Palisades Nuclear Plant  
Operated by Nuclear Management Company, LLC

Nuclear Management Company Response to Request for Additional Information RE:  
Relief Requests for Reactor Vessel Head Penetrations at the Palisades Nuclear Plant

**ENCLOSURE 1**  
**NUCLEAR MANAGEMENT COMPANY RESPONSE TO REQUEST FOR**  
**ADDITIONAL INFORMATION RE: RELIEF REQUESTS FOR REACTOR VESSEL**  
**HEAD PENETRATIONS AT THE PALISADES NUCLEAR PLANT**

STEP 6  
REMEDIATION

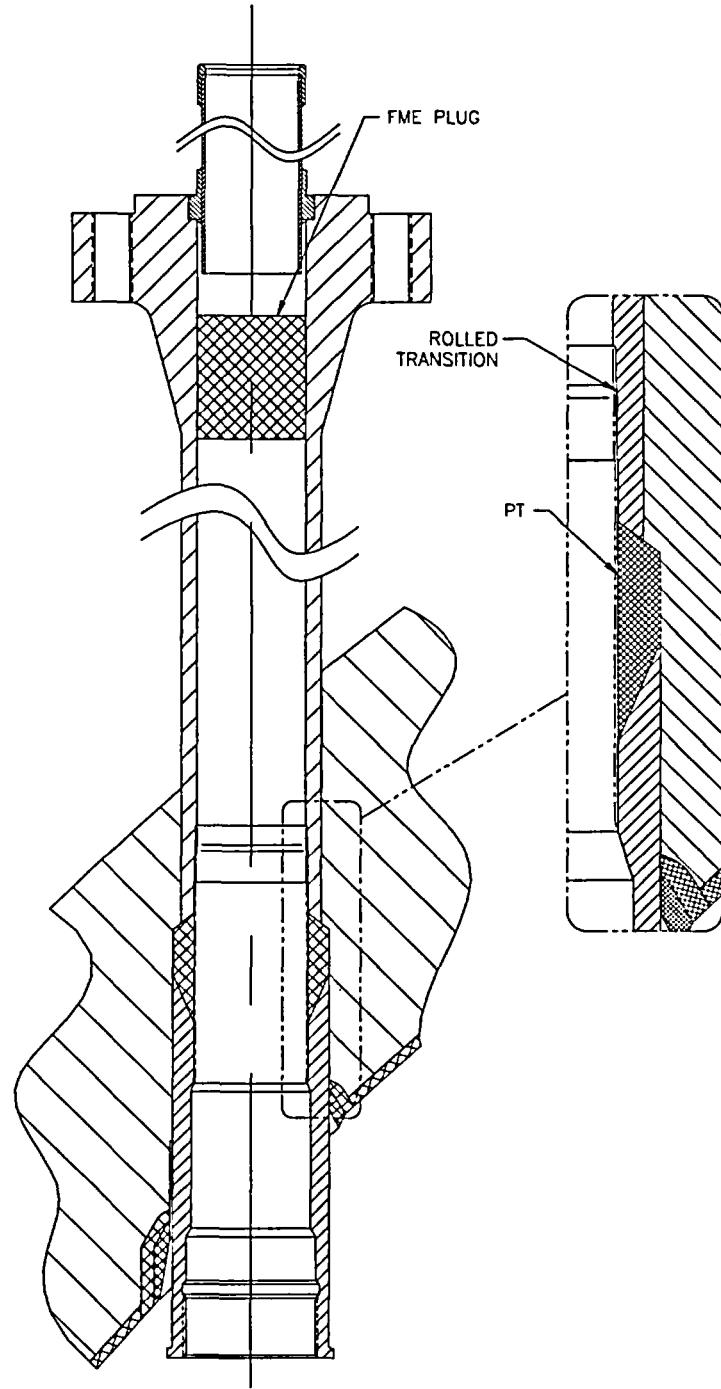
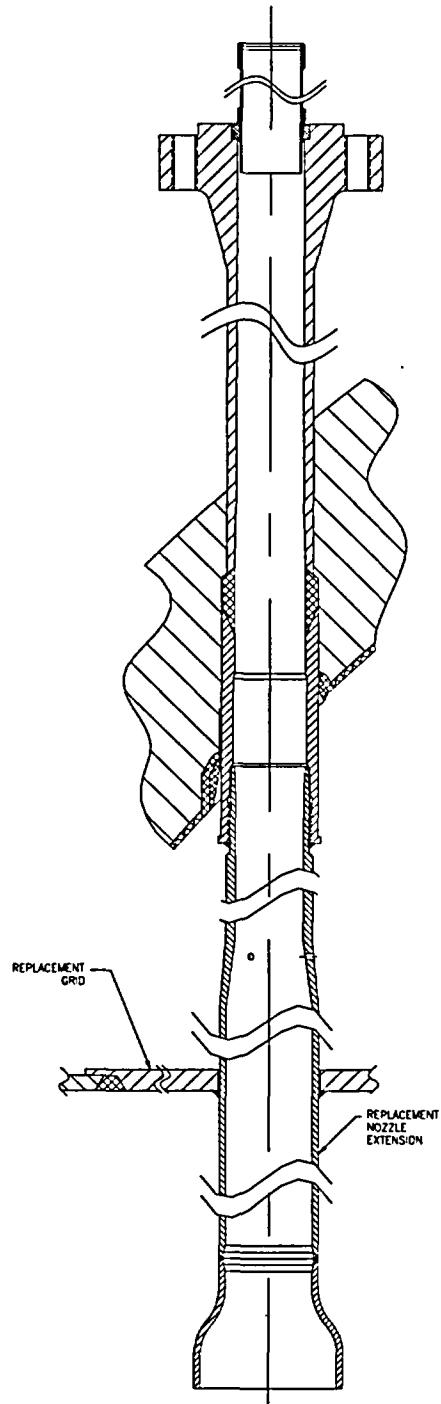
1. *The reactor vessel head penetration repair is described briefly on page 4 of AREVA document 32-5043862 in Attachment 2 to Relief Request #1. The staff needs detailed description. (1) Submit a document (or reference a document that has been submitted previously) that describes the repair plan, or discuss in detail step-by-step repair of the control rod drive (CRD) nozzle and incore instrumentation (ICI) nozzle. (2) The discussion should include physical dimensions of the components such as wall thickness, diameter, length of the CRD and ICI nozzles, and thickness of the repair weld. (3) Discuss how the lower portion of the nozzle is removed from the closure head bore and detached from the J-groove weld. (4) Discuss whether removal of the nozzle will cause crack initiation in the J-groove weld. (5) Discuss why the inside of the replacement nozzle is divided into several segments with various inside diameters and wall thickness. (6) Discuss whether various inside diameters in the replacement nozzle will cause lateral movement of the control drive mechanism shaft. (7) Discuss whether the metal surfaces (base metal and original nozzle) are cleaned before the repair weld is made.*

1. (1) A detailed process outline of the control rod drive mechanism (CRDM) and in-core instrumentation (ICI) nozzle repair is described below. Provided in Attachment 1 are figures that show the nozzle configuration during the process. The repair process is the same for the CRDM and ICI nozzles, except as noted in the process outline.
  - a. Ultrasonic (UT) the weld repair area.
  - b. Cut tube grid structure adjoining the target nozzle and surrounding CRDMs. (CRDM only)
  - c. Cut the nozzle and remove the nozzle extension close to the underside of the head.
  - d. Roll expand nozzle body.
  - e. Clean the bore.
  - f. Bore the lower nozzle OD slightly oversize up to the location of the repair weld. The lower portion of the remaining nozzle is beveled suitable for welding.

(5) The replacement nozzle ID contains 3 different diameters. In the installed orientation, the upper ID matches the ID of the original CRDM/ICI nozzle. The middle ID is slightly larger than the upper ID so that the time required to final machine the new weld is minimized (total length of the replacement lower nozzle machined is limited to length of upper ID). The lower ID is slightly larger than the middle ID so that the replacement nozzle extension can "nest" inside the replacement nozzle, thereby creating a smooth transition. (See step 7 of the attached CRDM repair figures provided in Attachment 1).
